Fire Marshal Division

Re: USPS Facility
Cameron, NC

Application Number BCOM1808-0006

Name of Project: **USPS Spout Springs Interior Upfit**

LS1.0 Architectural
Life Safety Plan

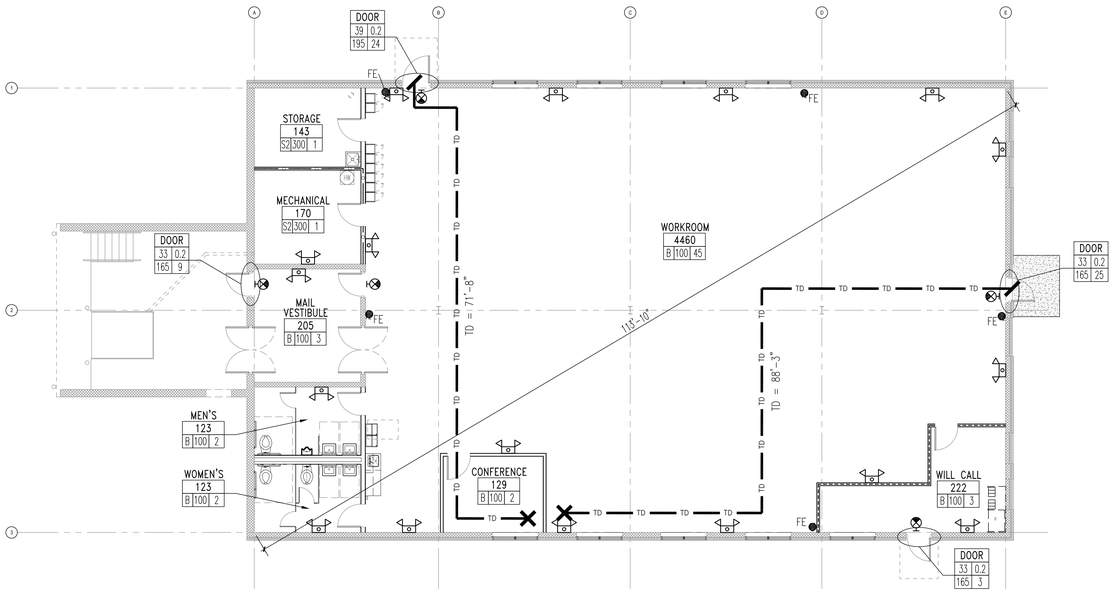
- **906.1 Fire Extinguishers**
  - Fire extinguishers shall be placed in approved locations and may be field verified on final inspection.
  - The fire extinguishers provided shall have a minimum rating of 2A 10B: C and shall not be installed higher than 5 feet above the finished grade.

- **1011 Exit Signs**
  - Exits and exit access doors shall be marked by an approved exit sign readily visible from any direction of egress travel.

- **1006 Means of Egress Illumination**
  - The means of egress, including the exit discharge, shall be illuminated at all times building space served by the means of egress is occupied.
  - The means of egress illumination level shall not be less than 1 foot-candle at the walking surface.
